RE: Response to U.S. EPA's Review of PROPOSED Title V Permit No. 0010006-001-AV
Gainesville Regional Utilities - Deerhaven Generating Station

Re: EPA Objection to PROPOSED Title V Permit No. 0010006-001-AV
Gainesville Regional Utilities (GRU) – Deerhaven Generating Station

SUBJ: EPA's Review of Proposed Title V Permit No. 0010006-001-AV
Gainesville Regional Utilities - Deerhaven Generating Station

**U.S. EPA Region 4 Objection
Proposed Part 70 Operating Permit
Gainesville Regional Utilities - Deerhaven Generating Station
Permit no. 0010006-001-AV**

**Gainesville Regional Utilities
Deerhaven Generating Station
Unit 2**

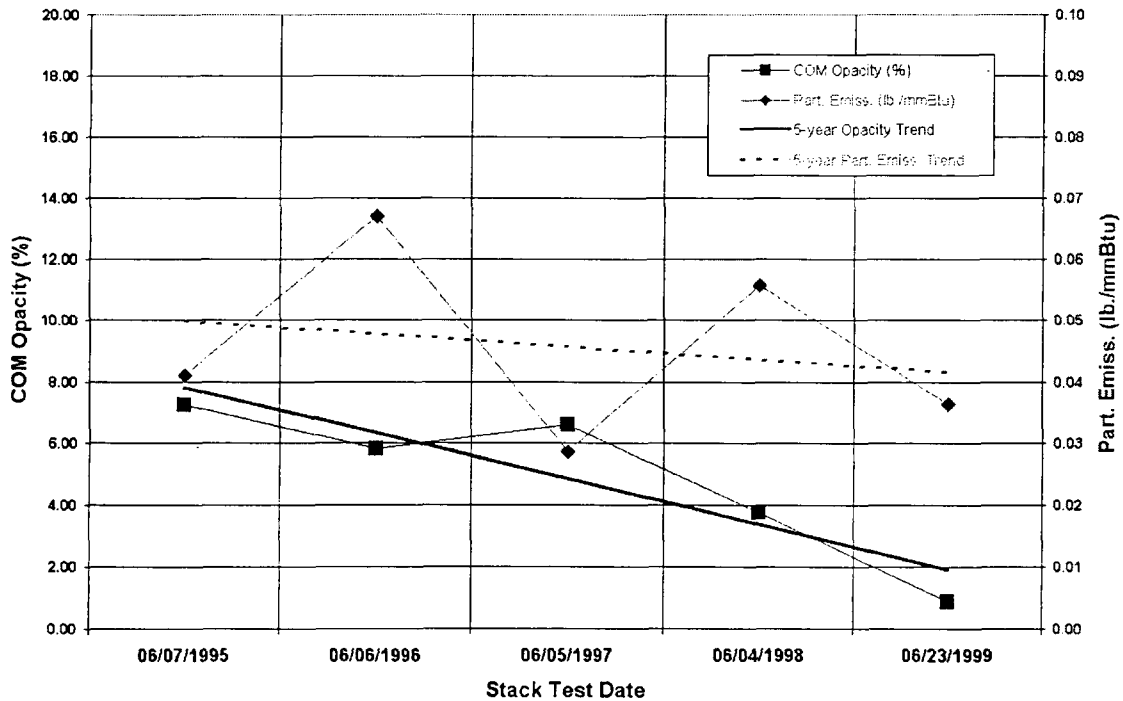
1. Periodic Monitoring - The permit does not contain adequate periodic monitoring for particulate matter emissions from boiler units #1 and #2. Although the source is required to conduct compliance tests for particulate matter, testing once per year is not sufficient to provide a reasonable assurance of compliance with emission limits. All Title V permits must contain monitoring that is sufficient to assure compliance with the applicable permit requirements. In particular, 40 C.F.R. Part 70.6 (a)(3)(B) requires that permits include periodic monitoring that is sufficient to yield reliable data from the relevant time period that are representative of the source's compliance with the applicable emission limits. In addition to demonstrating compliance, a system of periodic monitoring will also provide the source with an indication of their emission unit's performance, so that periods of excess emissions and violations of the emission limits can be minimized or avoided. Therefore, the permit should include a periodic monitoring scheme that will provide data which is representative of the source's actual performance.

Alternatively for boiler unit #2, since PM emissions are controlled with an electrostatic precipitator, an appropriate form of periodic monitoring for particulate matter would be to monitor certain parameters on the control equipment. The permit should specify a performance range for each parameter, that will provide a reasonable assurance that the source is in compliance with the applicable limit.

Unit 2 is a coal-fired boiler with a 20% opacity limit and a 0.1 lb/MMBtu particulate matter limit. The table below presents PM test results and contemporaneous COMs data for 1995 - 1999.

As this table indicates, the particulate matter and opacity emissions are well below the permitted limits and trending downwards as shown in the figure below. The Department believes this data justifies annual testing for Unit 2.
